WATERFORD 3

CORE OPERATING LIMITS REPORT

FOR CYCLE 10

REVISION 1

COLR Figure 9

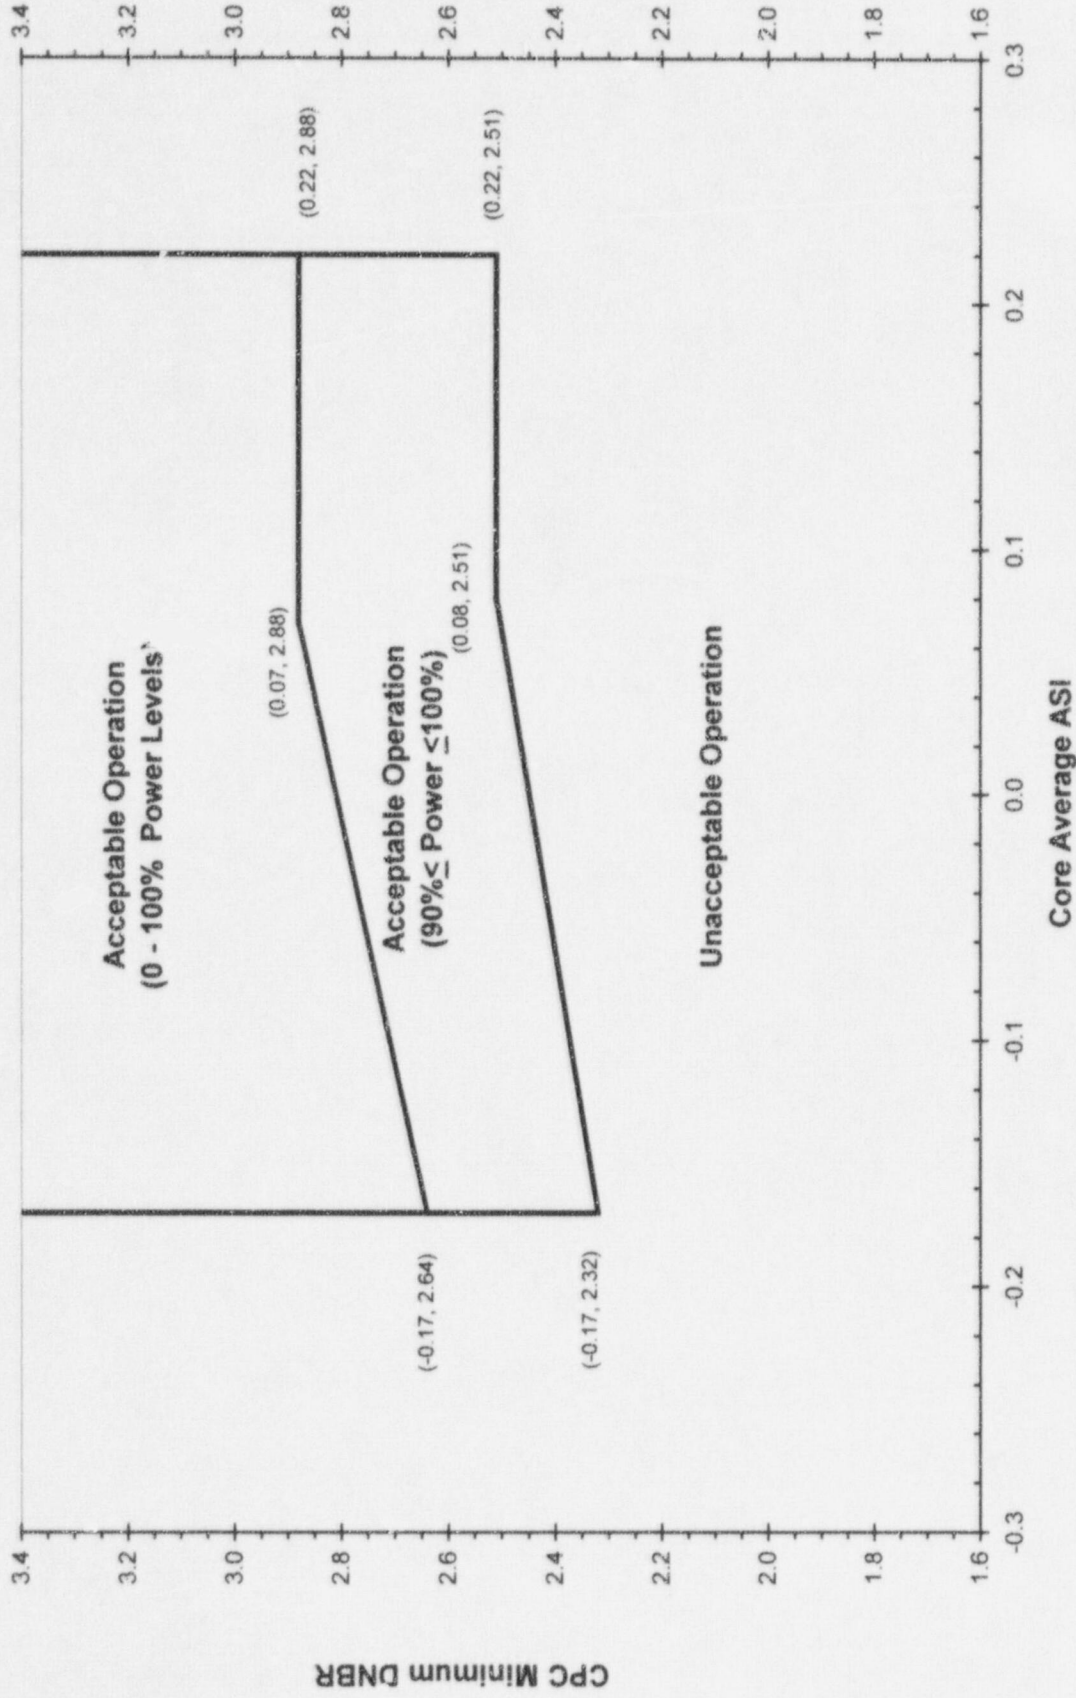
1. Figures 8 and 9 have been revised to address new DNBR limits with COLSS Out-of-Service when the CEACs are Operable or Inoperable.
